**TENTATIVE ORDER**

**SITE CLEANUP REQUIREMENTS FOR:**

**GUADALUPE MINE  
GUADALUPE RUBBISH DISPOSAL COMPANY, INC.  
SAN JOSE, SANTA CLARA COUNTY**

**Figure 2. Storm Water Collection and Flow to Creeks**  
 Drainage basins are outlined in brown for the Mine, which is located on the southeastern portion of the Site.

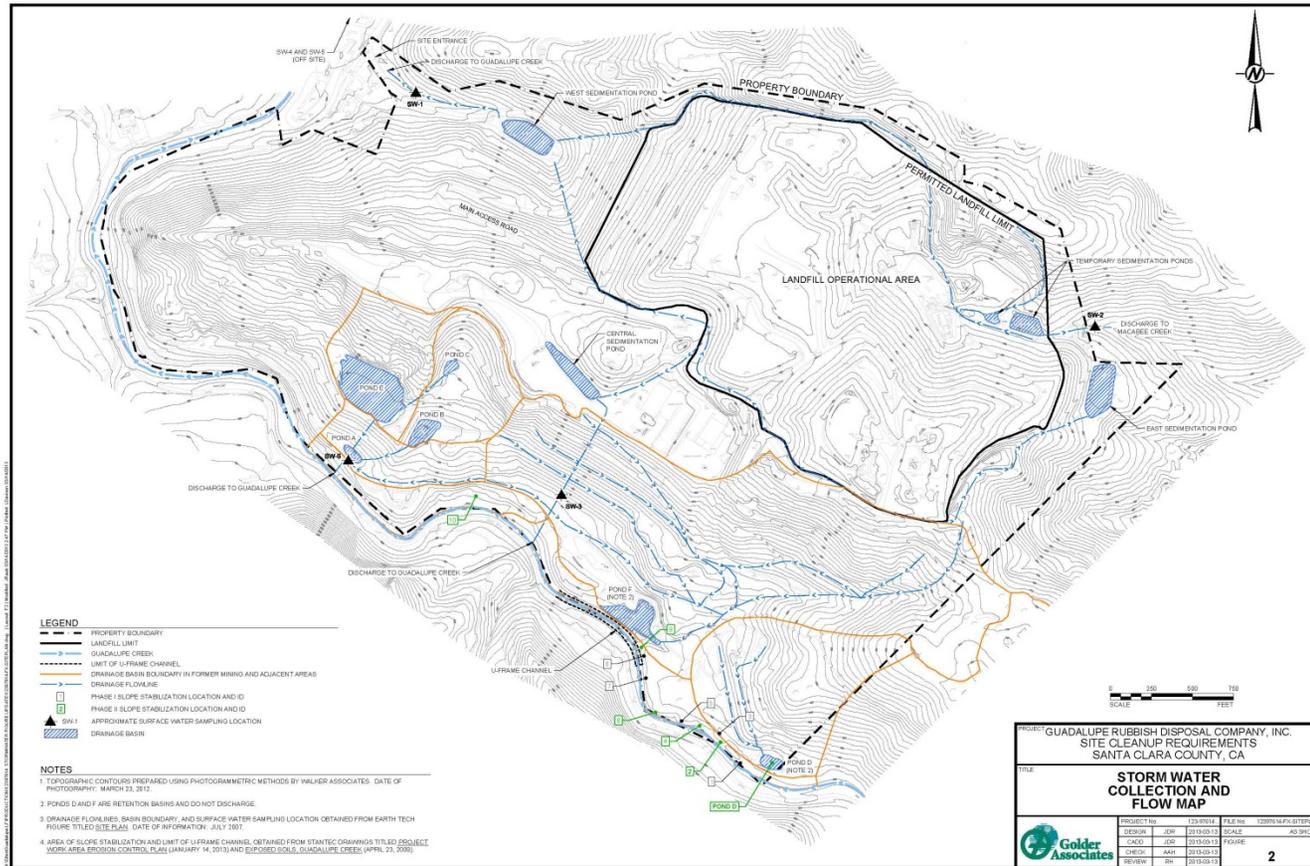
- (c) Revised figures of Storm Water Collection and Flow to Creeks (Figure 2 herein) and Former Mining Operations, Waste Piles, and Facilities Map (Figure 3 herein).

- (i) Figure 2 must be revised to indicate (a) drainage conveyances and pathways for the entire property, including the northwest portion of the Site, and (b) 300- foot-long stretch of mining waste in Guadalupe Creek downstream of U-frame channel (refer to *Mercury Mine Waste Erosion Inventory: Rancho De Guadalupe Area Sierra Azul Open Space Preserve*, Revised, April 2011 available at [http://www.waterboards.ca.gov/sanfranciscobay/water\\_issues/programs/TMDLs/guadaluperivermercurytml.shtml](http://www.waterboards.ca.gov/sanfranciscobay/water_issues/programs/TMDLs/guadaluperivermercurytml.shtml)); and

**Figure 3. Former Mining Operations, Waste Piles, and Facilities Map**

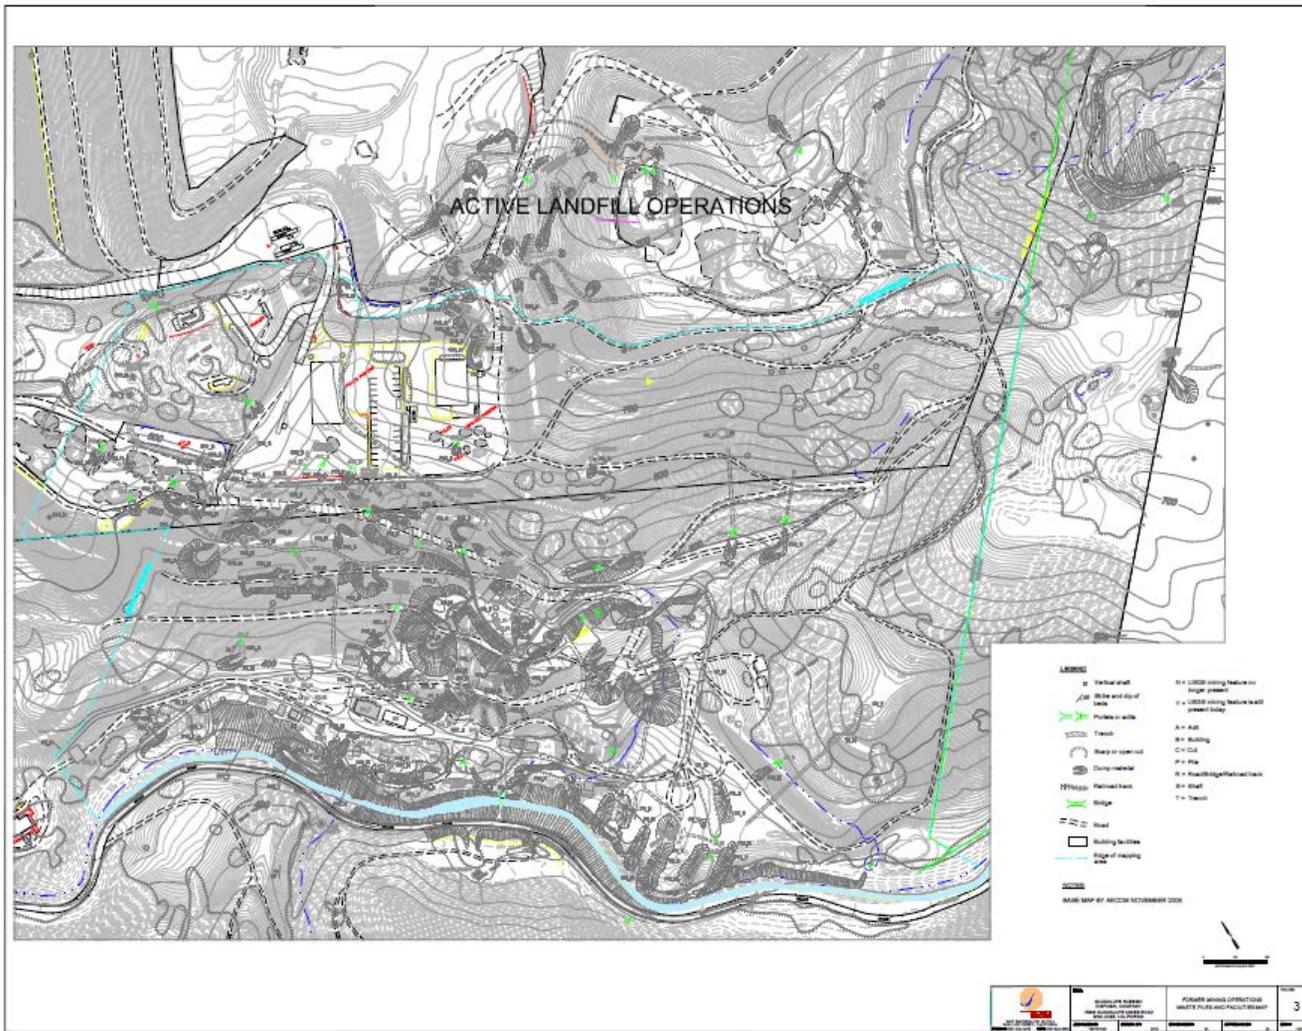
- (ii) Figure 3 must be revised to indicate (a) U-frame channel, (b) 300- foot-long stretch of mining waste from 2(c)(i)(b), and (c) furnace yards (refer to Slide 15 in Michael Cox's letter dated 29Aug2012).
